ADDENDUM NO. 1

DATE: 9-12-2023

TO: ALL BIDDERS  
FROM: JKF ARCHITECTURE  
RE: STAR Communications New Headquarters & Operations Buildings  
Project No. 2022-17

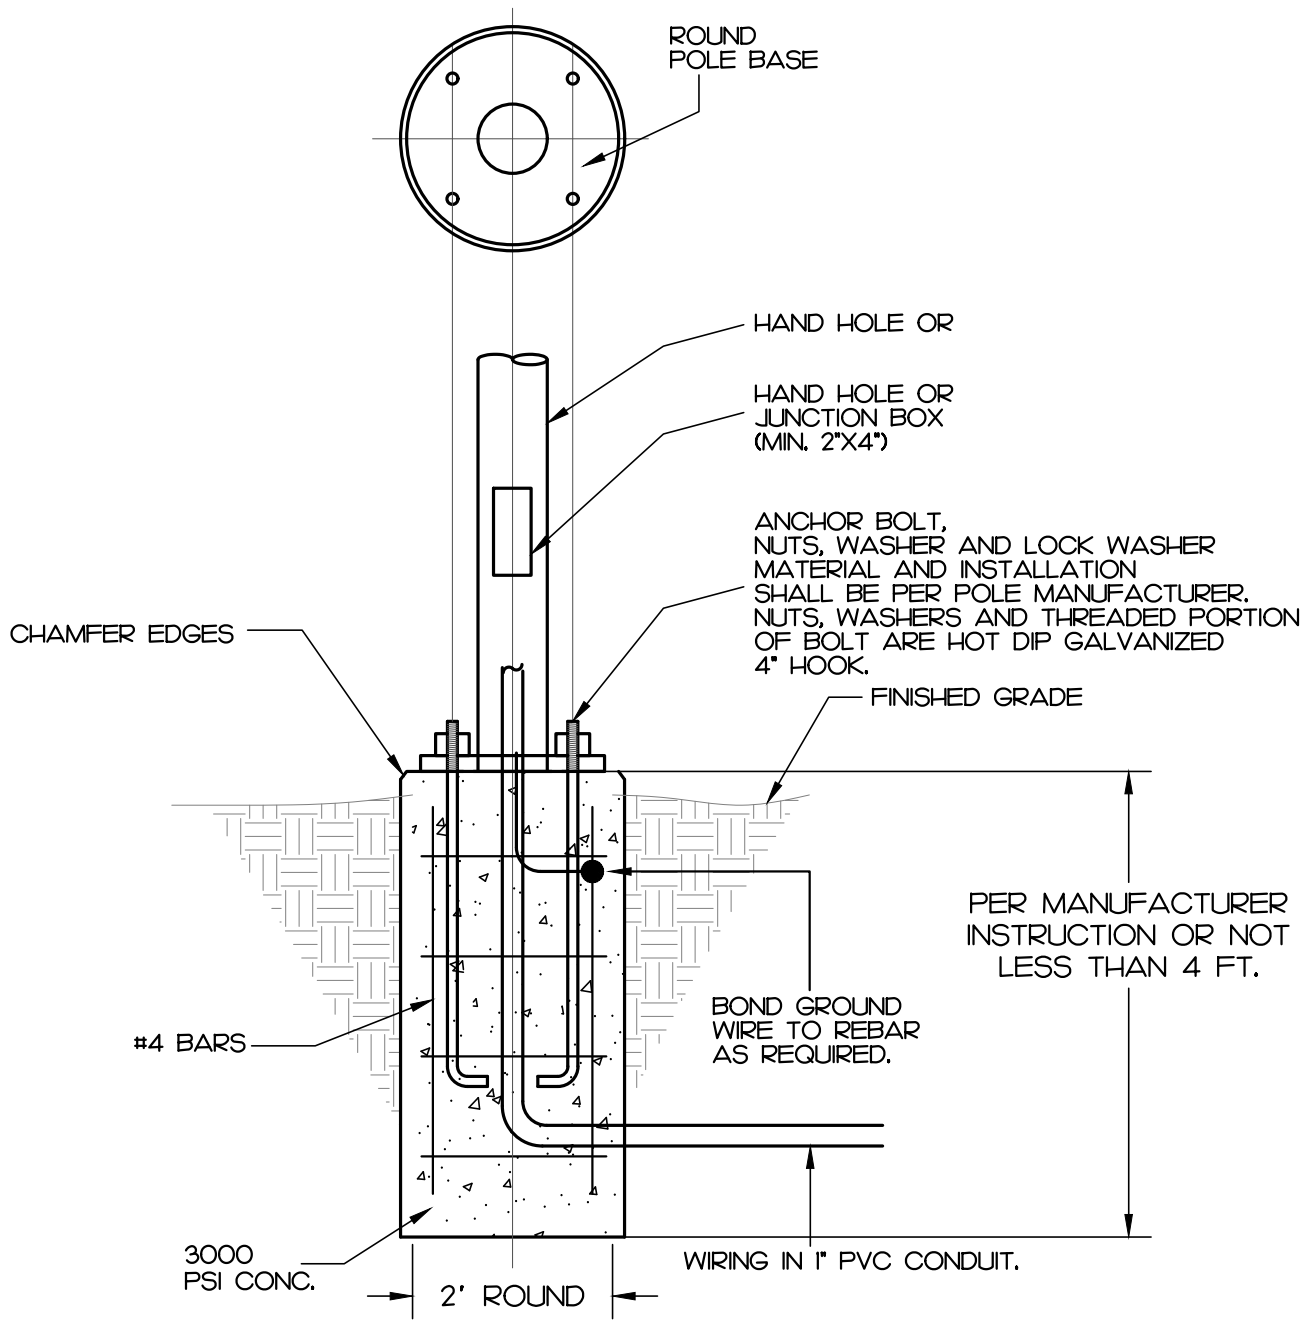
1. E1.0 – Island with traffic gates added to plans. An additional electrical connection for the second gate has been added. See bulletin drawing E1.0A for details.
2. E2.21 – A door to the low roof has been added to Stair 1. Door contacts have been added to the new door. See bulletin drawing E2.21A for details.
3. E5.3 – Contractor has requested a pole base detail. A pole base detail has been added to the plans. See bulletin drawing E5.3A for details.

- (13) E.C. TO PROVIDE BOLLARDS PER 2018 NCFC SECTION 312 FOR PROTECTION OF ELECTRICAL EQUIPMENT.
- (14) E.C. TO PROVIDE PAD PER UTILITY INSTRUCTION.
- (15) FIELD COORDINATE GATE OPERATOR INSTALLATION WITH OWNER AND ARCHITECT PRIOR TO ROUGH-IN. PROVIDE 1" CONDUIT FOR CONTROL WIRE AS REQUIRED.
- (16) CARD READER FOR GATE ACCESS. FIELD COORDINATE INSTALLATION WITH OWNER AND ARCHITECT PRIOR TO ROUGH-IN. PROVIDE 1" CONDUIT FOR CONTROL WIRE AS REQUIRED.

**SITE DETAILS**

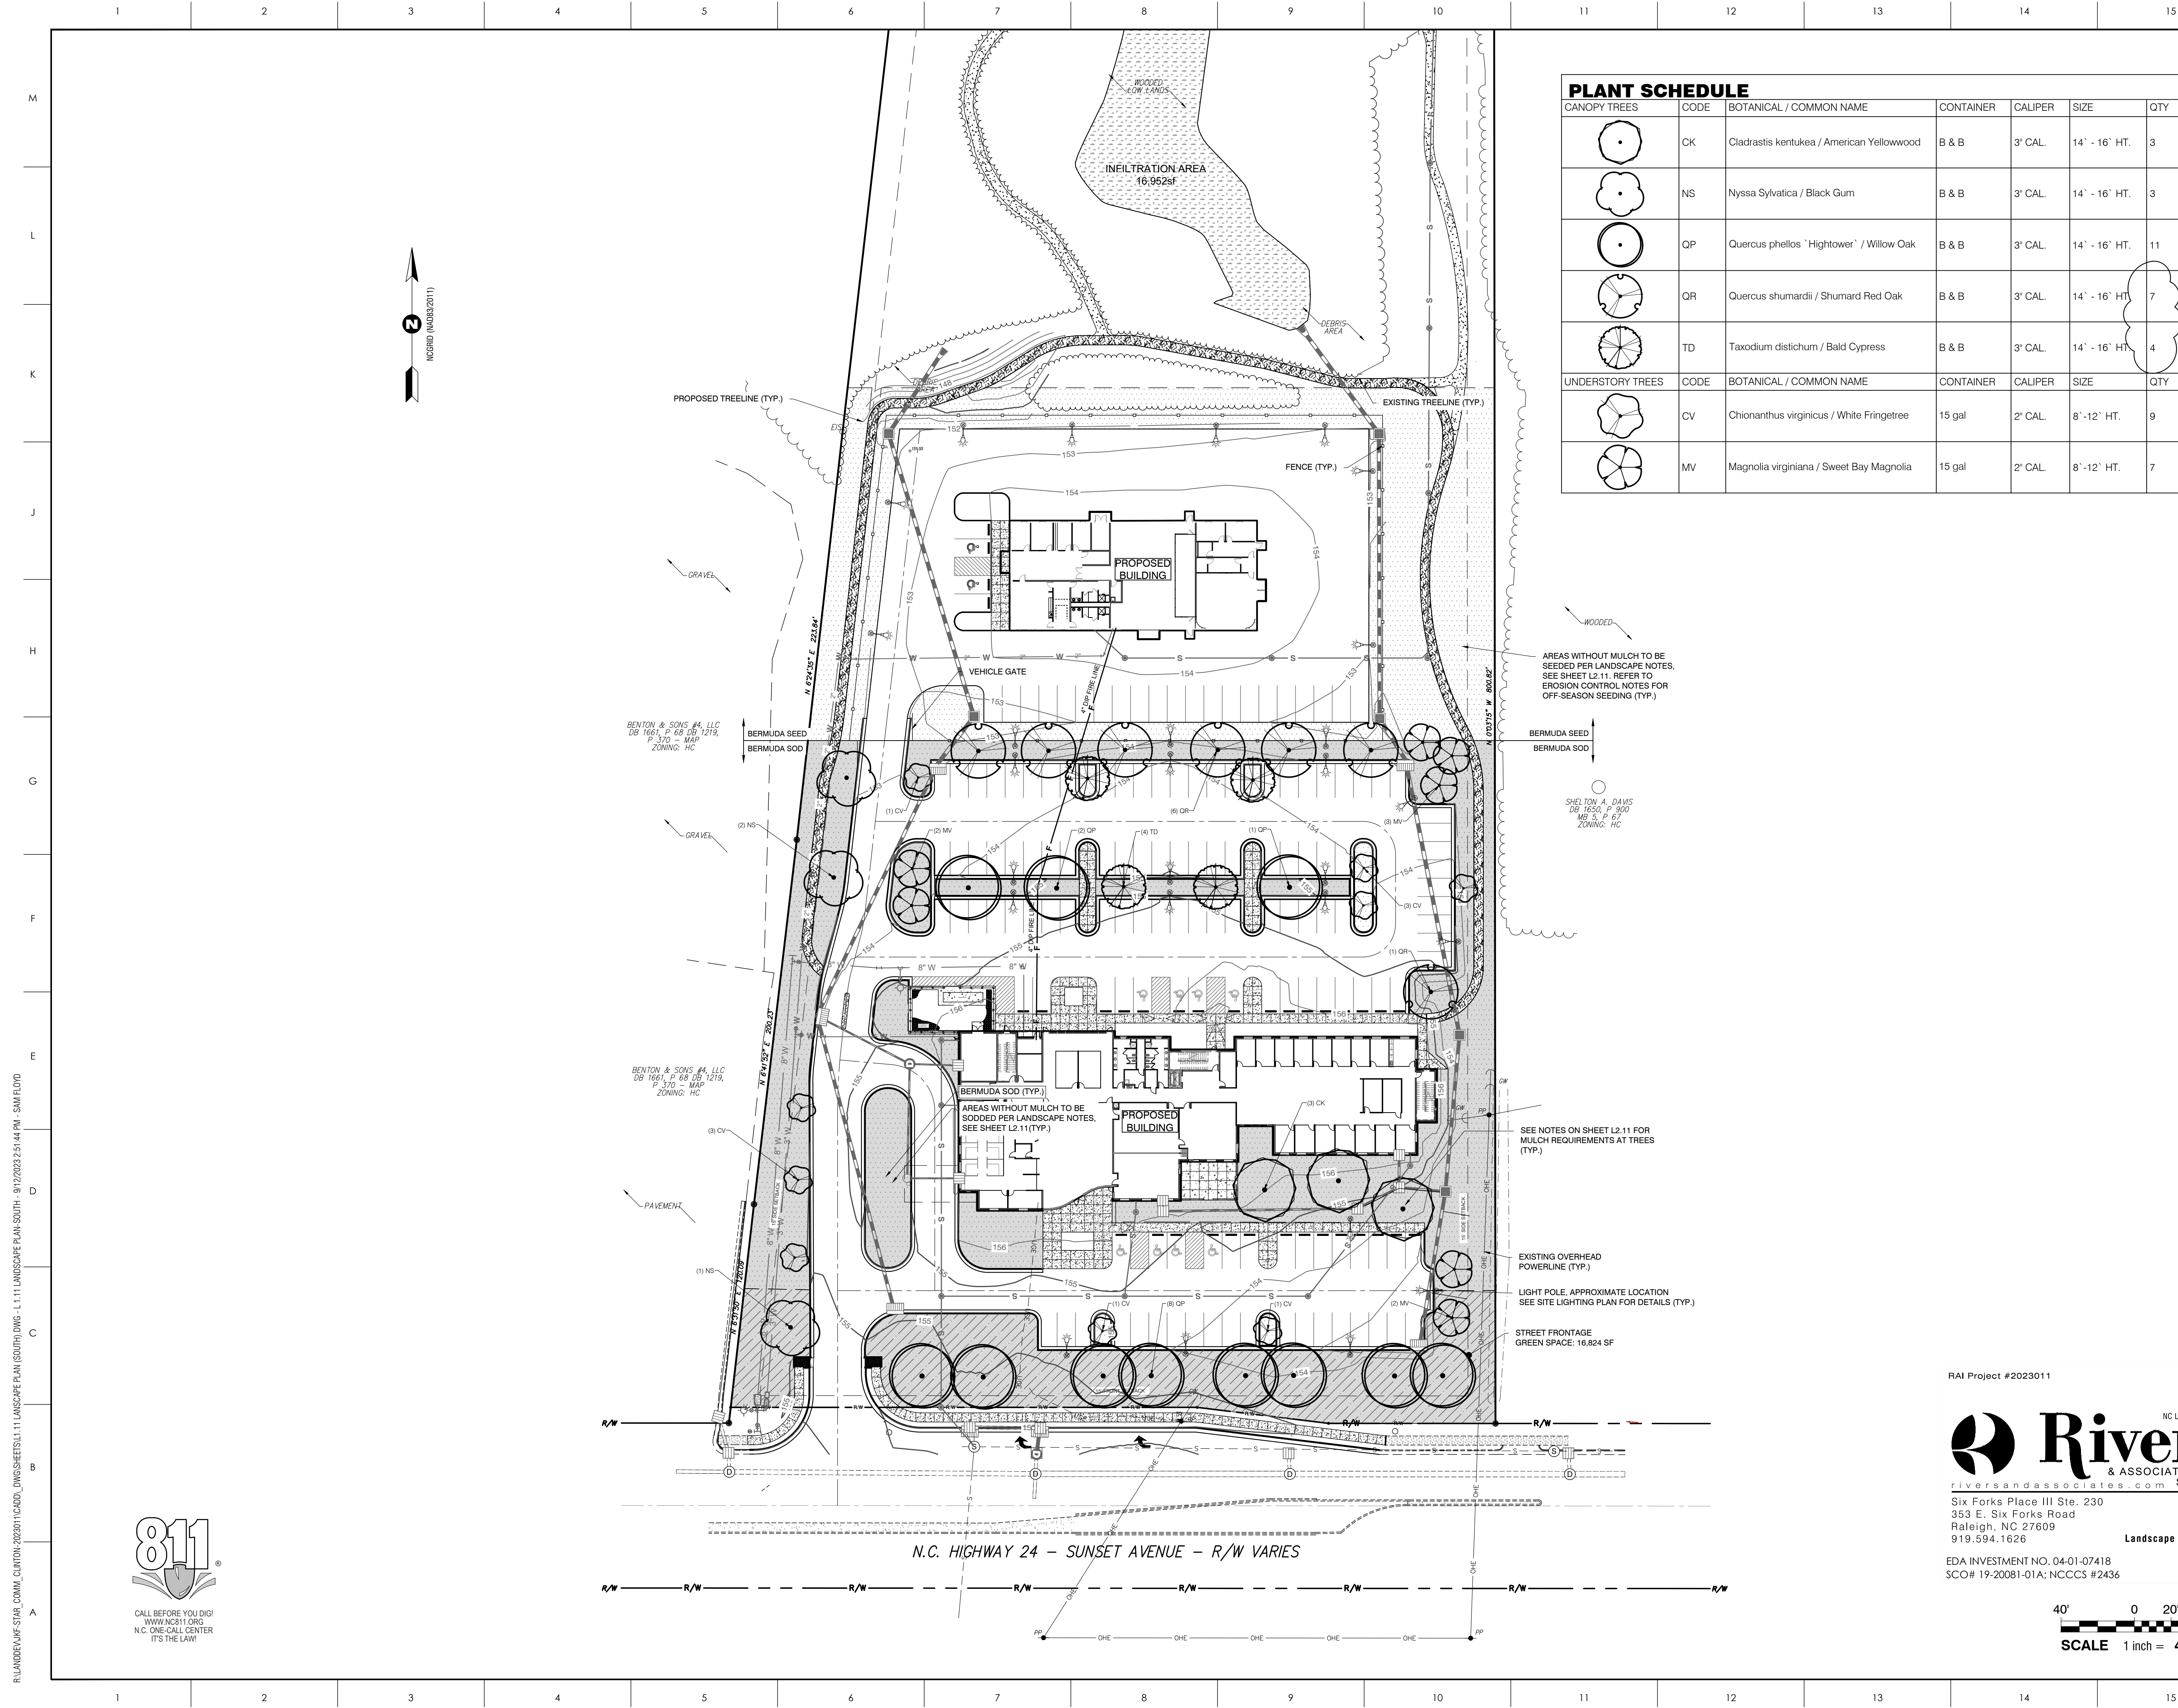
5. Regarding Window Types W1 through W9 shown on A8.1, and W1 shown on 2A8.1, the windows are truly divided lites as shown in all the wall sections for both buildings.
6. Reference Specification Section 095113; The wood ceiling finishes shall be selected from the full range of manufacturers available colors and species. The grid for the wood ceiling shall be a matching color to the selected for wood ceiling panels as selected by the Architect.
7. In response to question regarding sidewalks and picture framing extents, it will be required to provide all walks and concrete paved areas to utilize details on Drawing C5.1.

**S3.11**

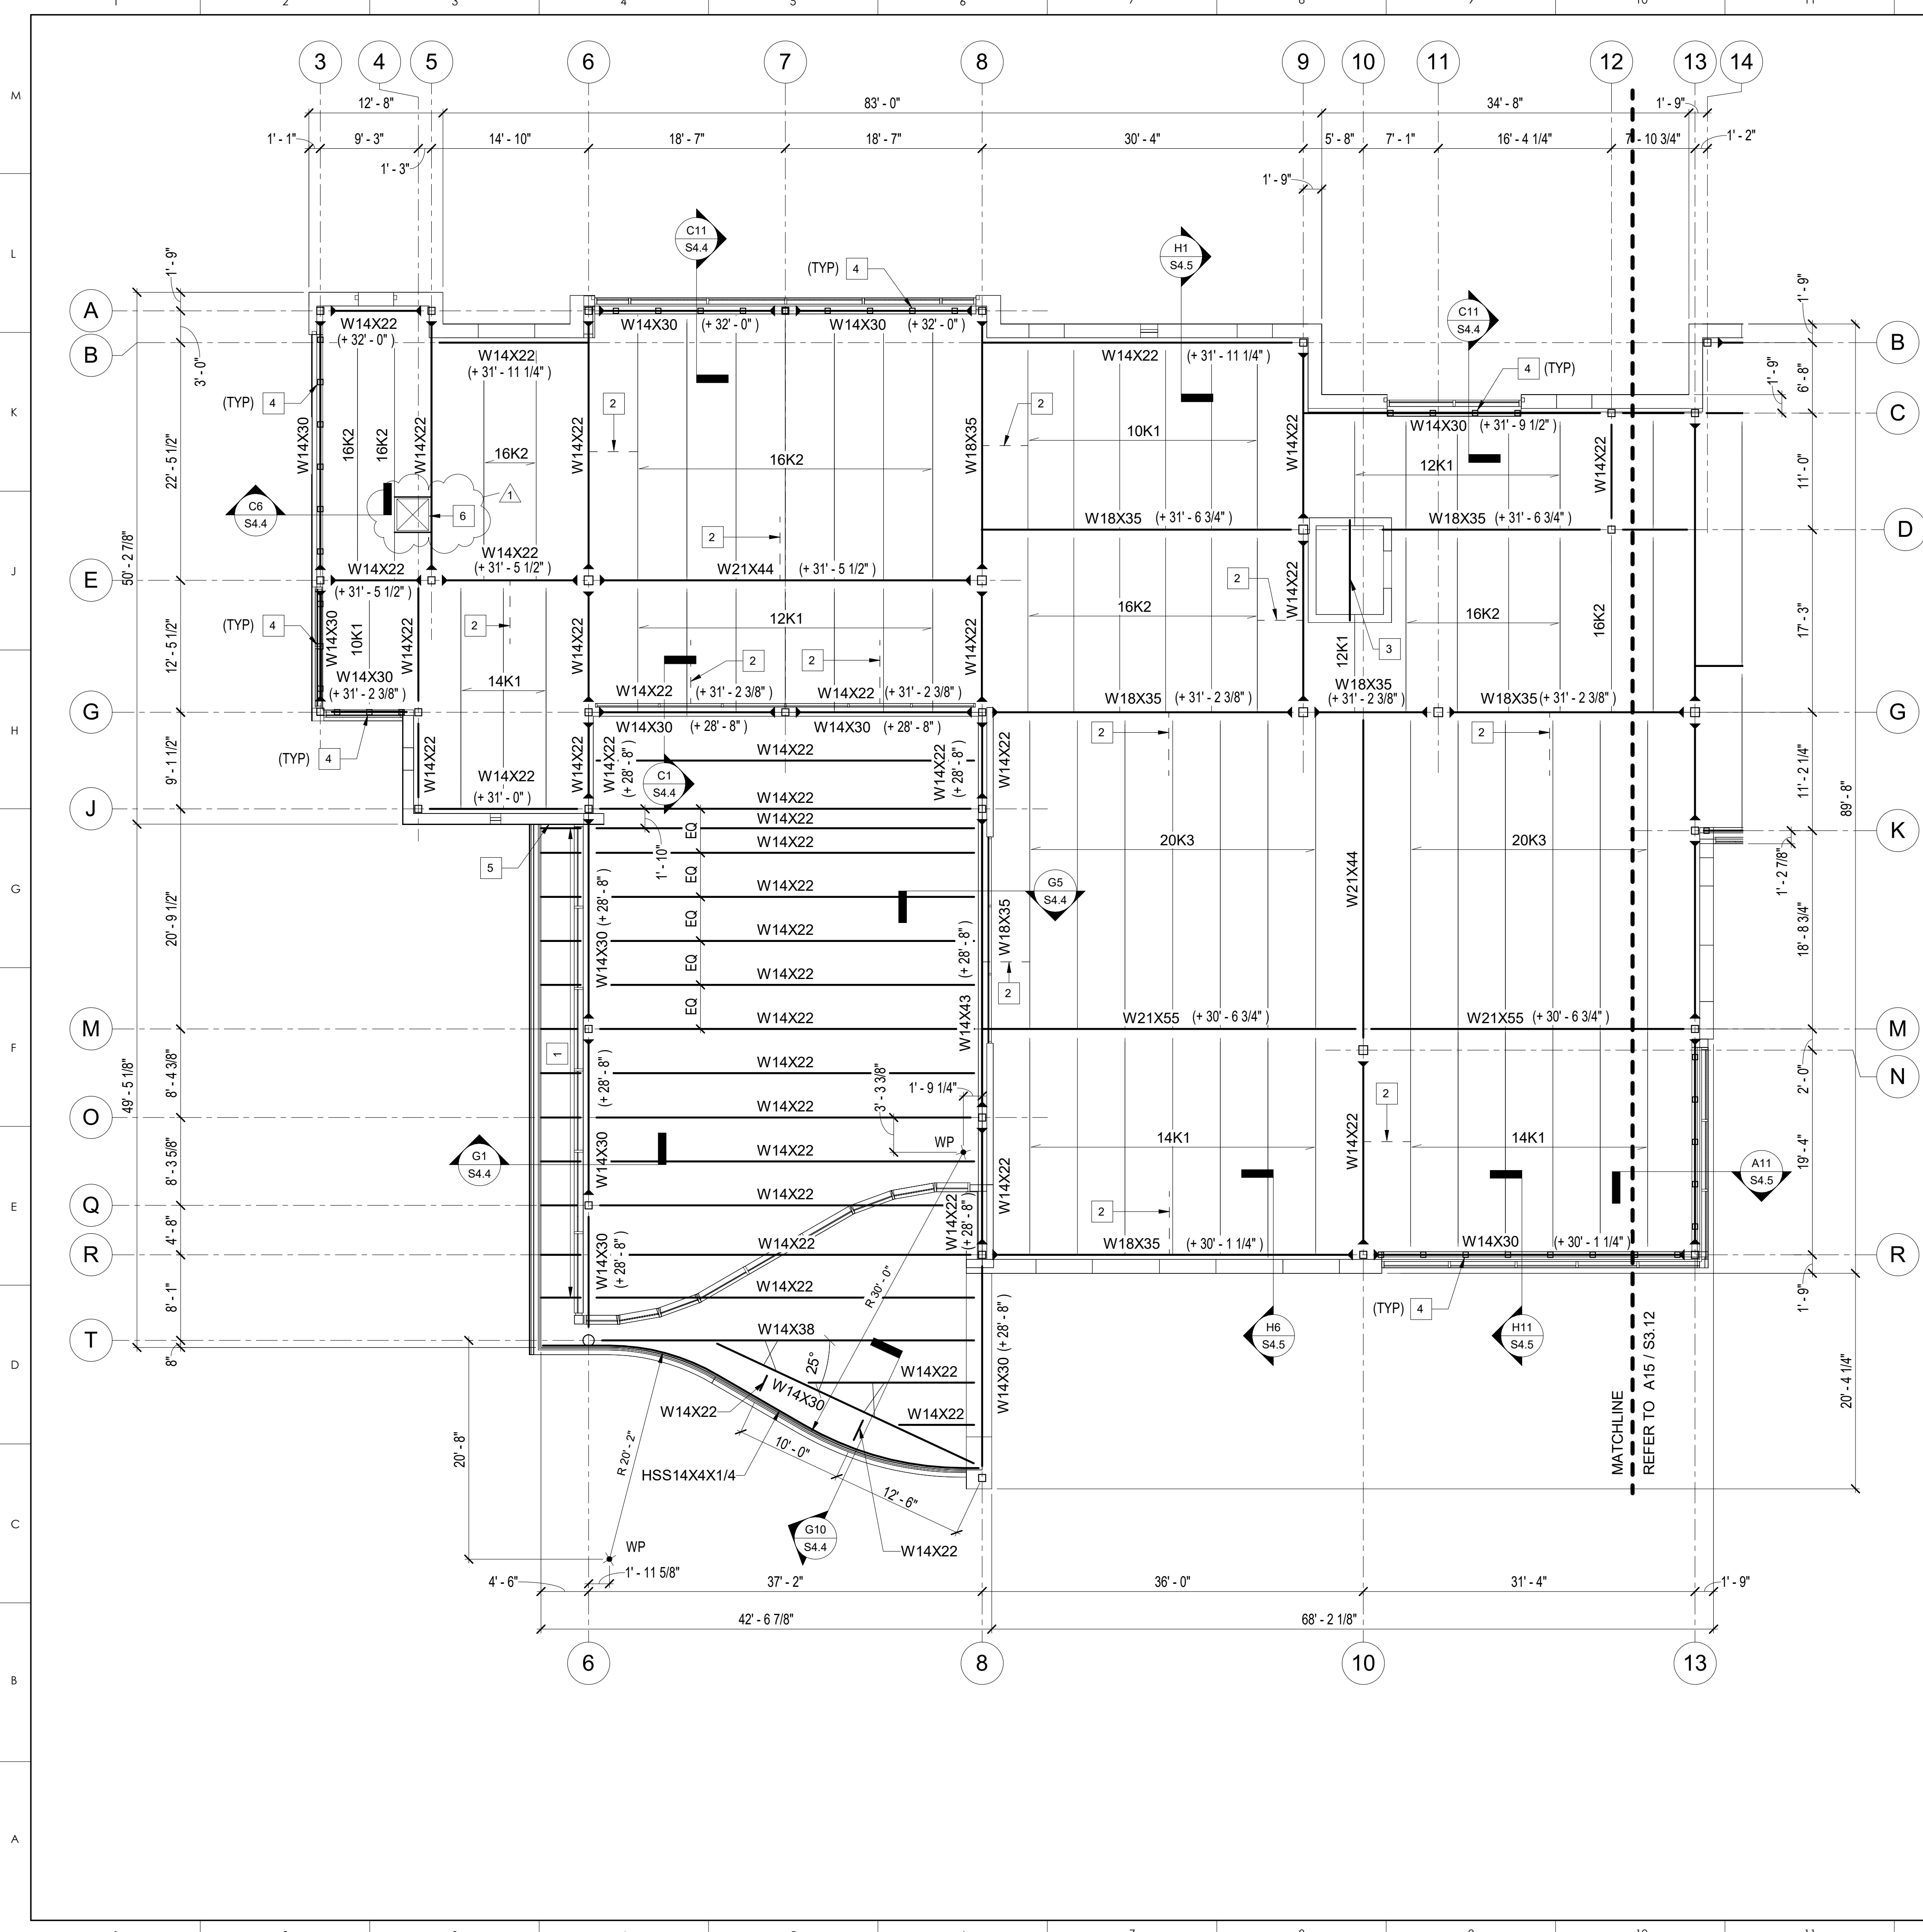
NO	REVISION	DATE
1	ROOF HATCH OPENING	9-12-2023
